2023 - 2024 RIDGEVIEW ELEMENTARY SCHOOL CORRECTION LIST

Occupant Name:	Ridgeview Elementary	Inspection Date:	3/8/2024
Address:	421 Jefferson Avenue	InspectionType:	Annual Fire Safety Inspection
Suite:	Orange Park	Inspected By:	Stephanie Raucci

CLAY COUNTY FIRE PREVENTION FIRESAFETY INSPECTION REPORT

Stage entrance at
R-132

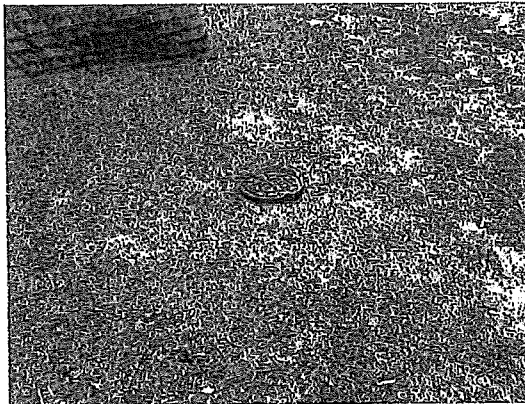
5.16 - Mechanical. (see photo 3.1)

Inspector Comments: The HVAC return cover is removed from the wall. Reset to wall.
